**Re: Health Care for the Homeless, 1220 First Street NW
Traffic Circulation Layout**
Architect's Stamp dated 9-26-14 (J14-D172)

Re: AHCH Albuquerque Health Care for the Homeless, 1220 First Street NW,
Traffic Circulation Layout
Architect's Stamp dated 9-26-14 (J14-D172)

TRAFFIC
CIRCULATION
LAYOUT

AS-001

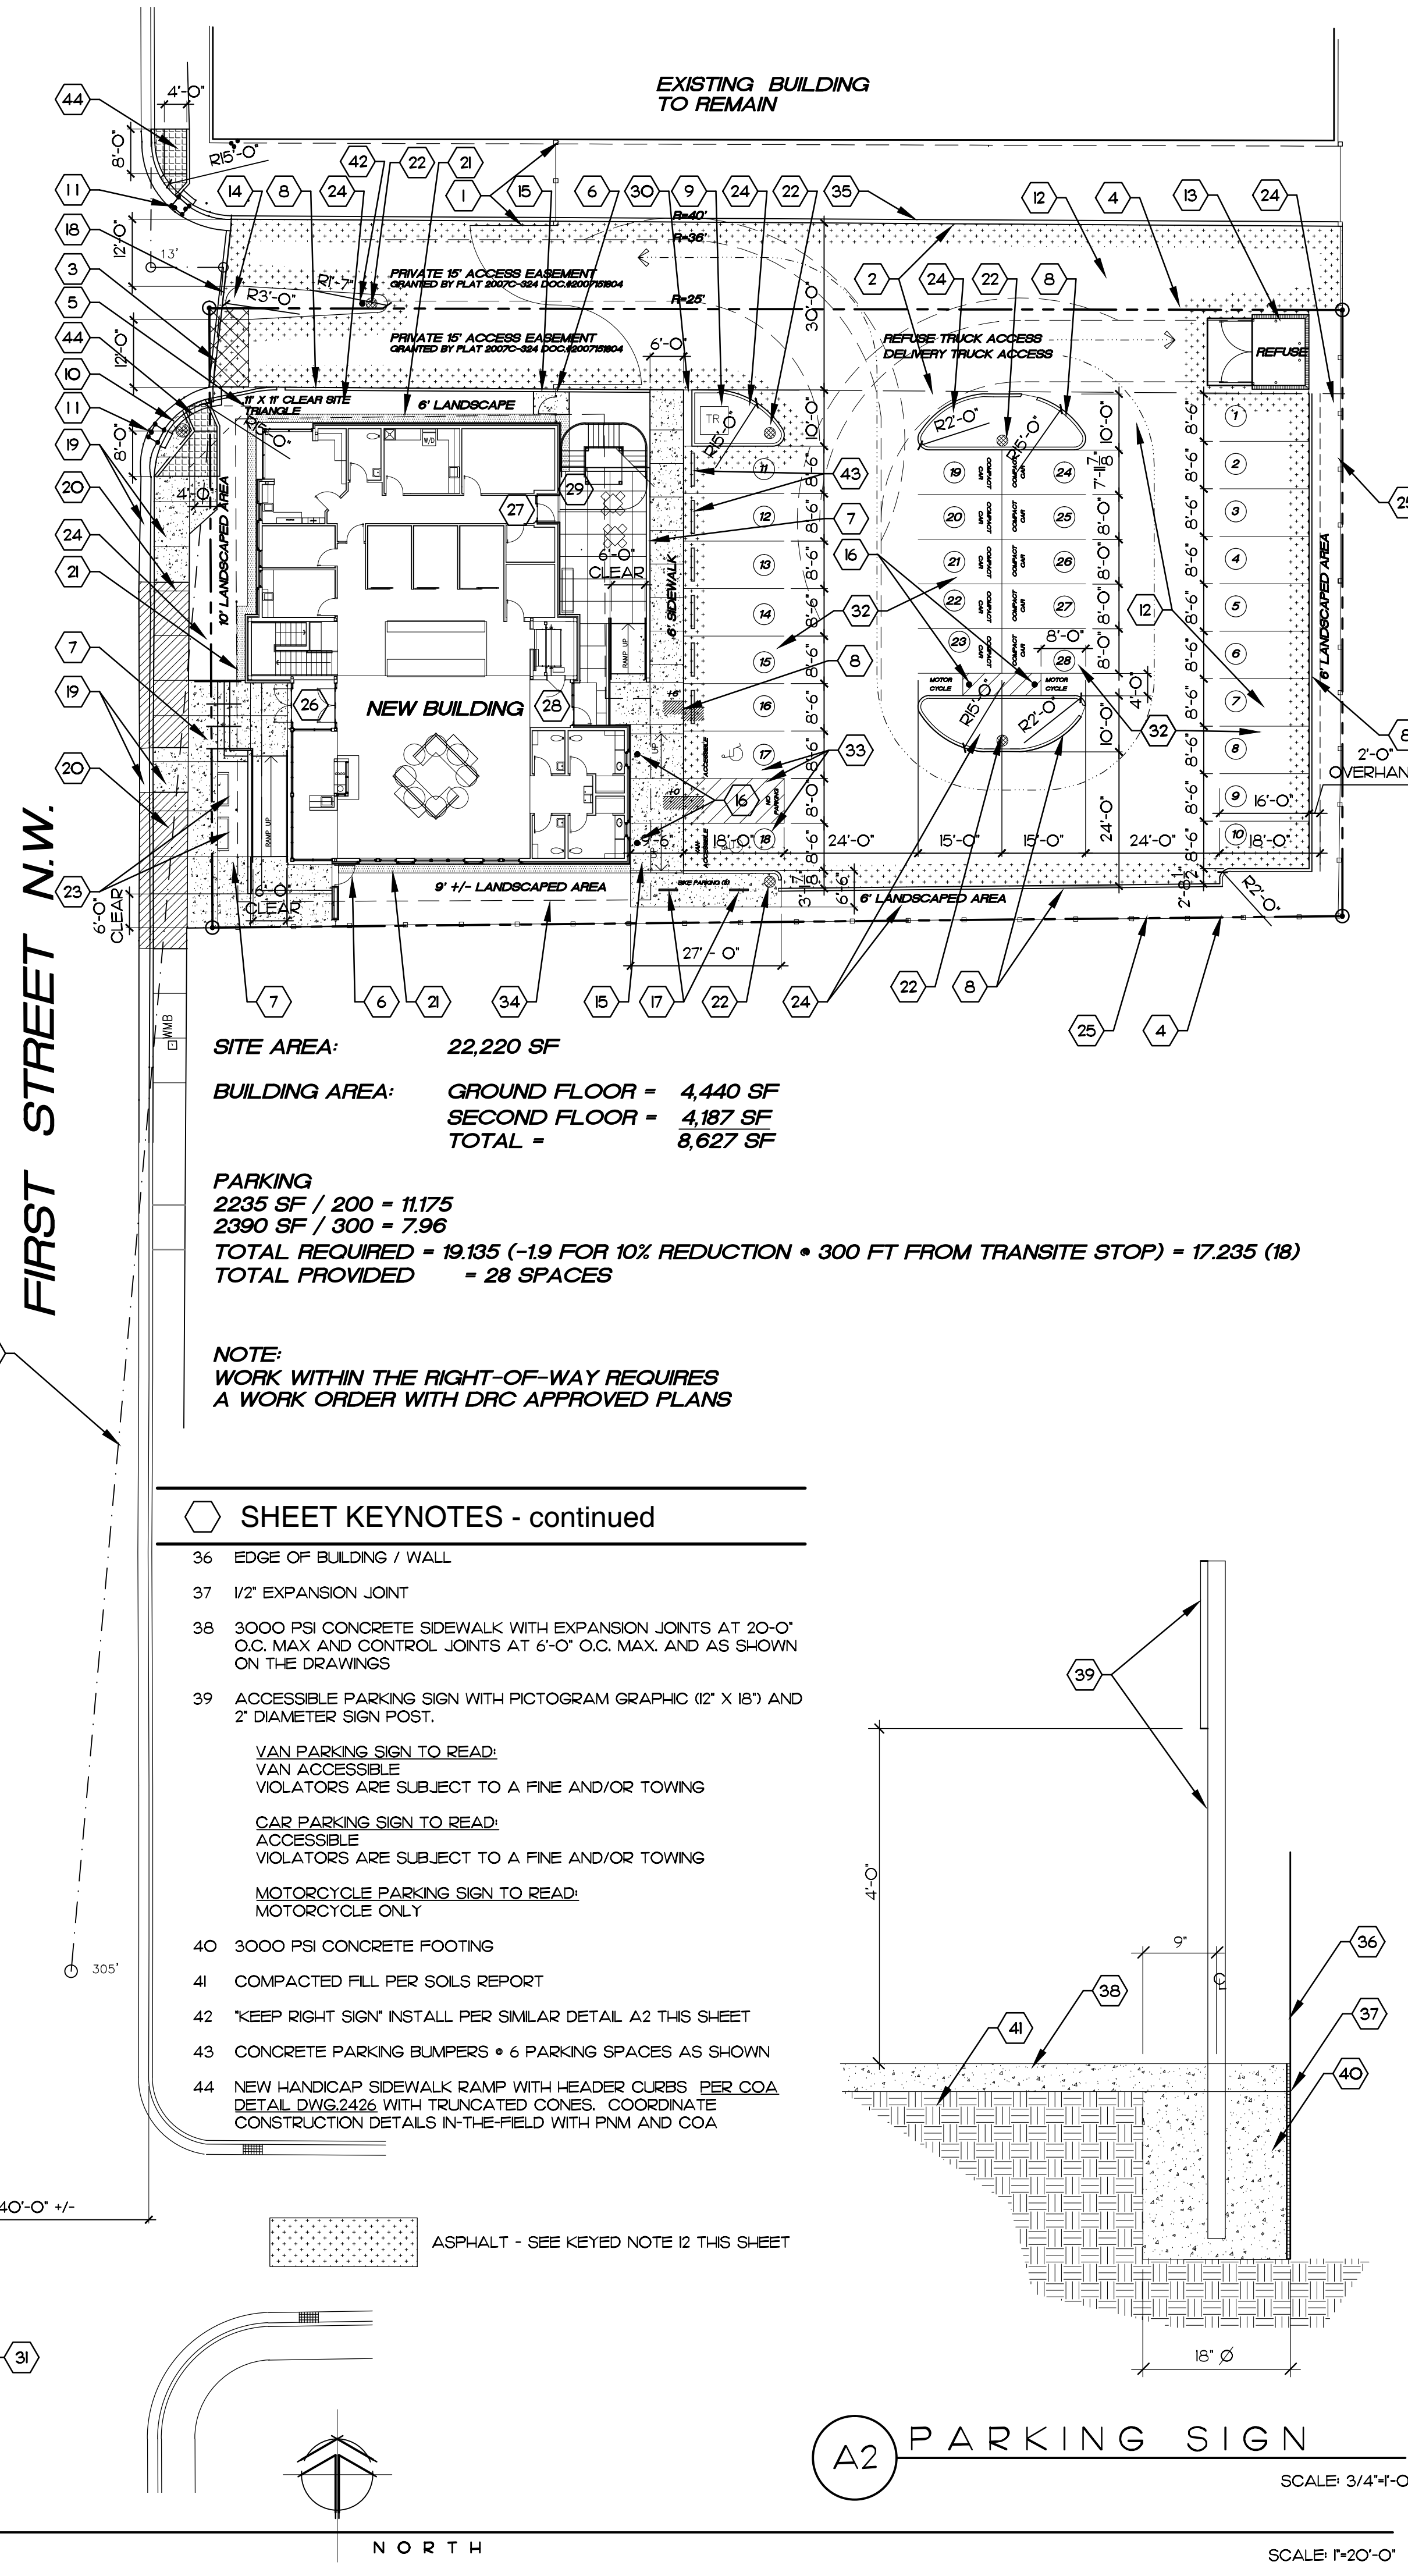
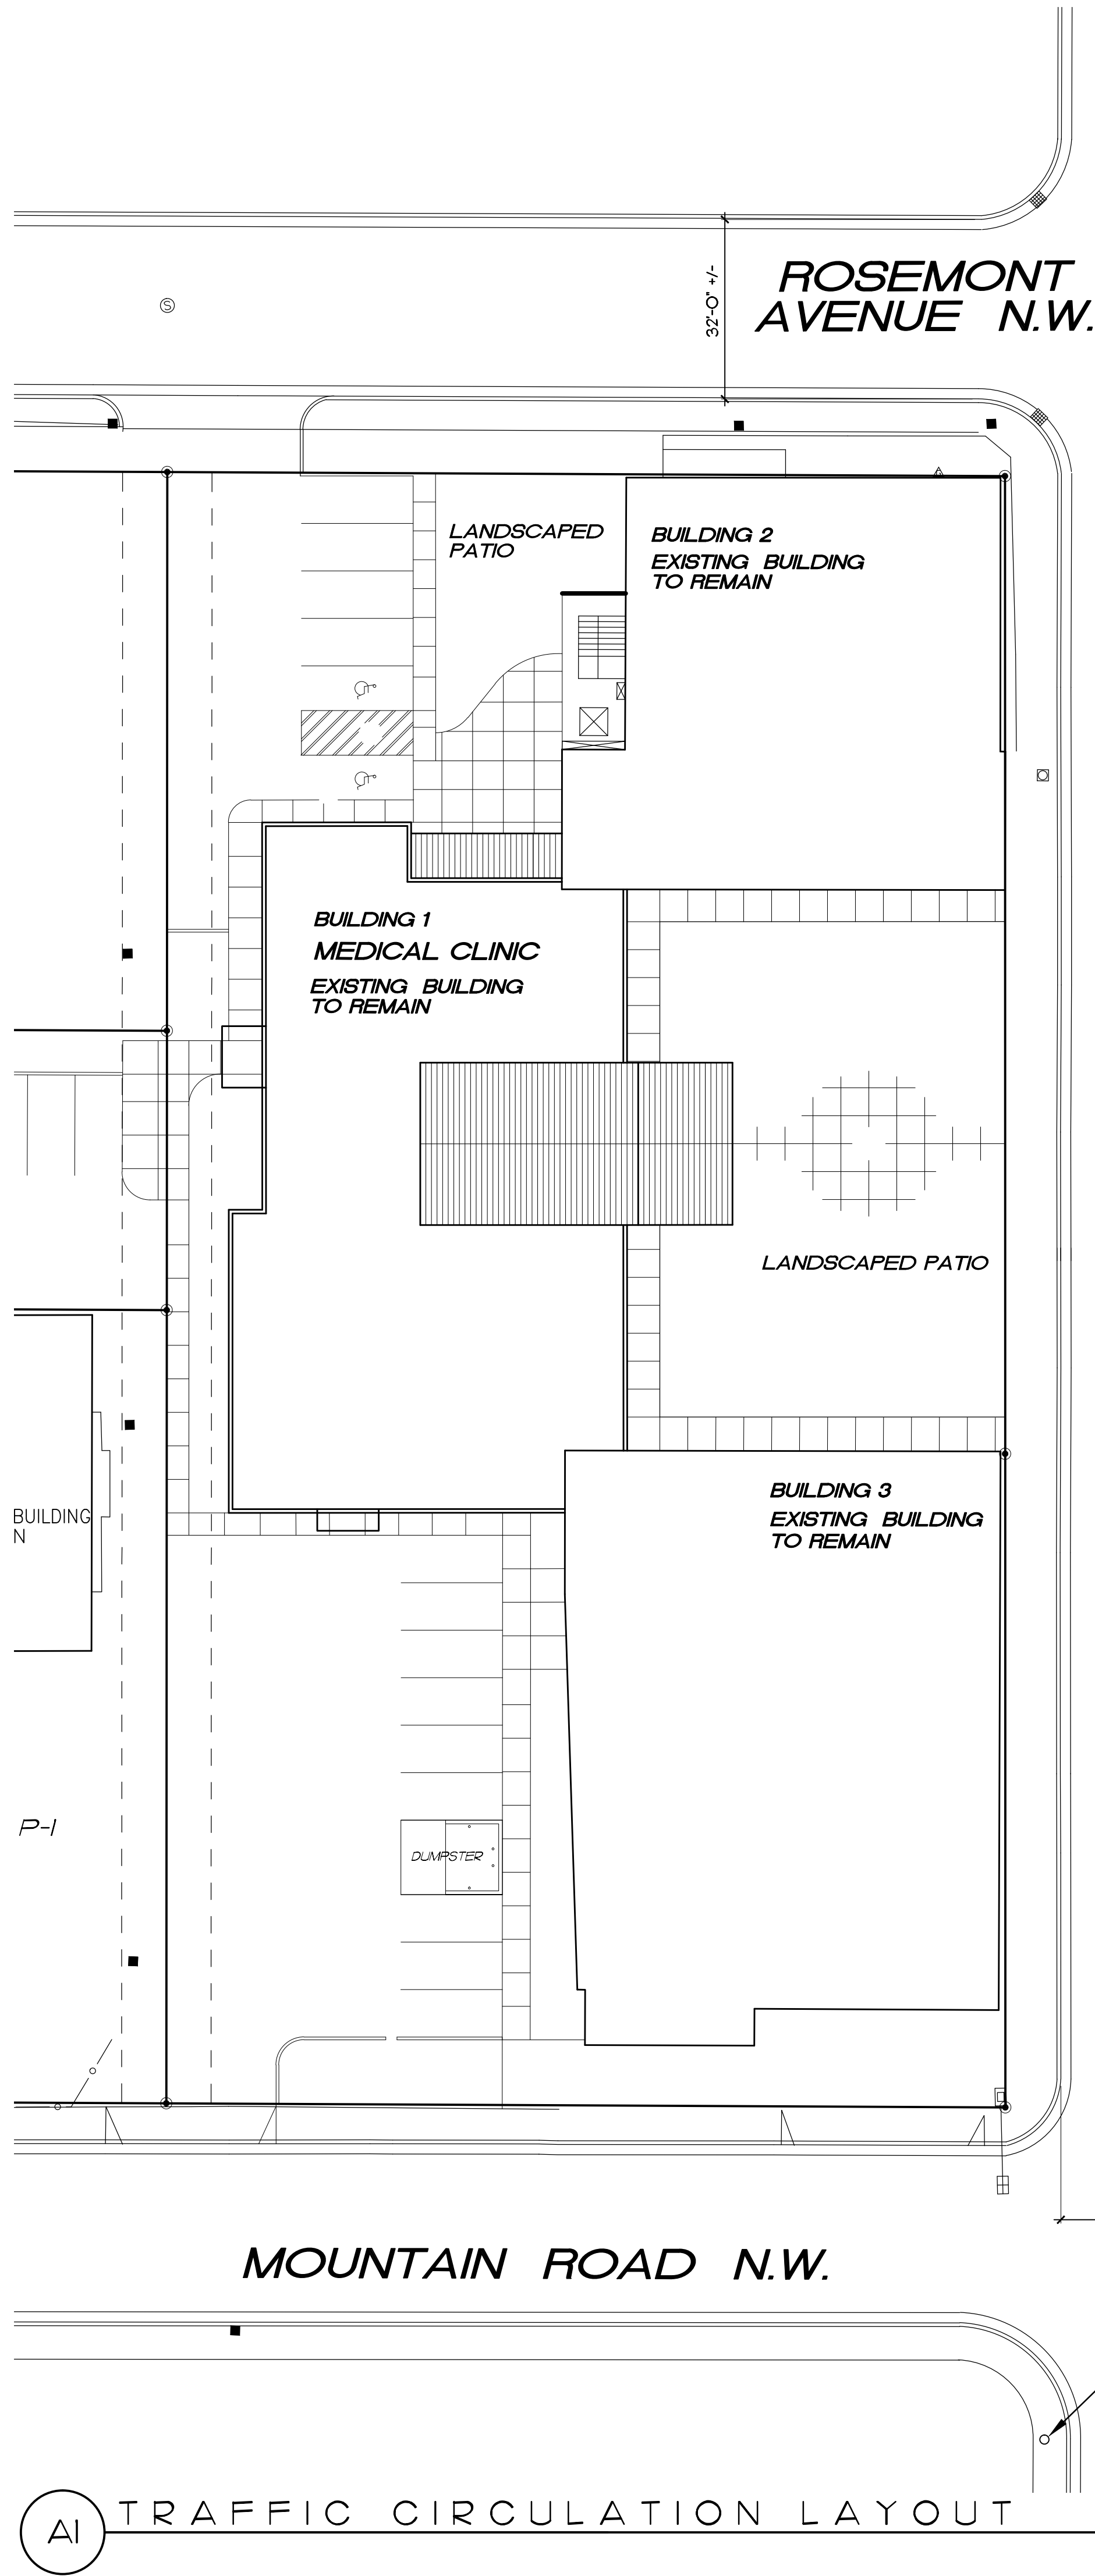
1. After reviewing the provided plat, there still needs to be some verification that the property owner to the north is in approval of the construction within his property. You may achieve this by having him sign a letter that he approves the paving improvements shown on the latest and greatest site plan or by having him give his signature on a copy of the latest site plan.

2. The wheelchair ramps across the 30-foot access easement look good in concept along with some of the dimensions that were added. However, the City of Albuquerque is unable to approve the site plan showing that the remaining construction details can be worked out in the field. Show the remaining details including remaining wheelchair ramp and truncated dome area dimensions, proposed easement dimensions, required slopes, and dimensioning and call-out of header curb. (The proposed spot elevations look like they will work to provide the required 2% cross-slope across the 30-foot access easement. Proceed to call out the 2% maximum cross-slope across the 30-foot easement.) Provide this detail within the set of plans.

3. Coordinate with Jane Rael (924-3992) regarding the required sidewalk easement for the south wheelchair ramp. The provided easement document is a separate document that needs to be done by a professional surveyor. To help you expedite the process of getting the project constructed, make sure that the easement is approved prior to Certificate of Occupancy. It does not have to be done prior to getting the Traffic Circulation Layout approved.

1. The Owner is trying to provide additional off-street parking to alleviate the congestion of on-street parking in the area. Some staff members from AHCH located across the street will use this parking lot.

2. Street widths are shown on the original drawing. The Rosemont dimension is located near the street label and the First Street dimension is located at the intersection of First and Mountain. The easement has been labeled as "Private 15-foot Access easement".

3. Handicapped spaces have been revised.
4. Parking spaces are 18' deep with 2' overhang. This is clarified on the revised drawing.
5. Detail was originally provided on sheet SITE501, and has been added to SITE000 (AS-001).

6. "No Parking" text size has been added to Keyed Note #33.
7. Radii at curb entrance, wheelchair ramps, and lane widths have been indicated on the revised drawing.

8. New PNM pole will be relocated 18" behind face of curb as shown on revised drawing.
9. "Keep Right" sign and yellow paint have been added to keyed Note #14.

10. Ramp has been widened to 6'-0" clear.
11. Ramp has been widened to 6'-0" clear.
12. 6" curbs were originally identified by elevation changes. Keyed Note #8 has been modified to also include this information.

13. Delivery route has been identified.
14. Keyed Note #12 originally indicated asphalt. This note has been modified to clarify the thickness.
15. Keyed Note #5 has been modified to include additional clarification regarding the clear sight triangle.

16. Easement was Granted by PLAT 2007C-324 (Doc.#2007151804) and this has been uploaded to the Documents Folder on the City Electronic Transmission site.

17. Per your previous e-mail, no DRC approval is required.
18. Two copies of revised drawing are included.
